Your Ref: MP-06-0162 - MOD 9

Our Ref: R/2008/16/J

Barangaroo Concept Plan MP-06-0162 Modification 9 - Response to Submissions

Figure 1. Approved and Proposed Blocks (Appendix C – SJB)

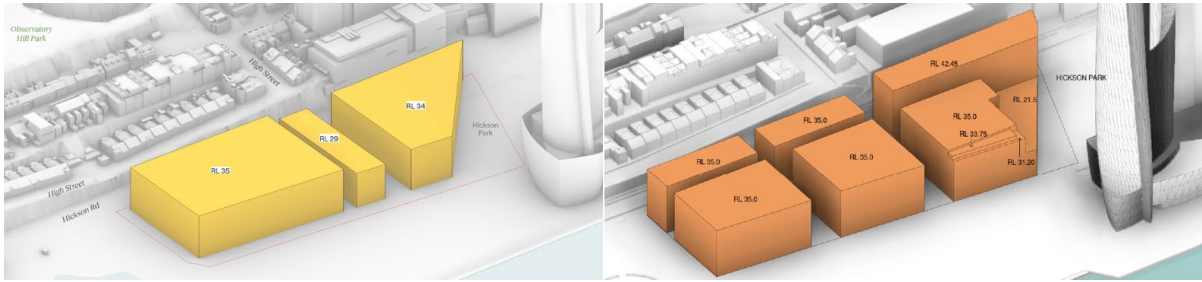
The amended proposed modification alters the block configurations and boundaries.

Consequently, the size of Hickson Park is proposed to be reduced by 1,625sqm or 14.2% in comparison to the approved Concept Plan, albeit the reduction is less than originally proposed under this modification application.

Figure 2. Wind Comfort extracts (SJB Appendix C, page 130)

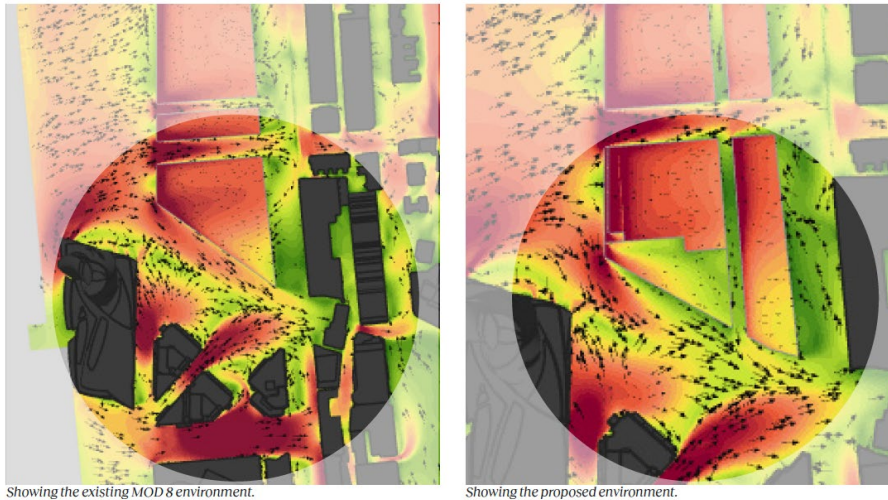
In addition, despite the claimed marginally improved wind comfort levels along the length of the northern promenade of Hickson Park, which inevitably benefits the proposed development, the narrowing of the gap between the northeastern corner of the Block Y and the southwestern corner of the proposed Block 5 envelope in turn increases wind impacts within the gap. The suggested trade-off between areas where wind comfort levels are improved or reduced does not provide a net public benefit, and not to the degree that would justify any reduction in the size of Hickson Park.

The Pedestrian Wind Assessment (Appendix F) does not provide any analysis of the approved concept envelopes. The comparisons to the predevelopment conditions serve little purpose in assessing the impacts of the proposed modifications.
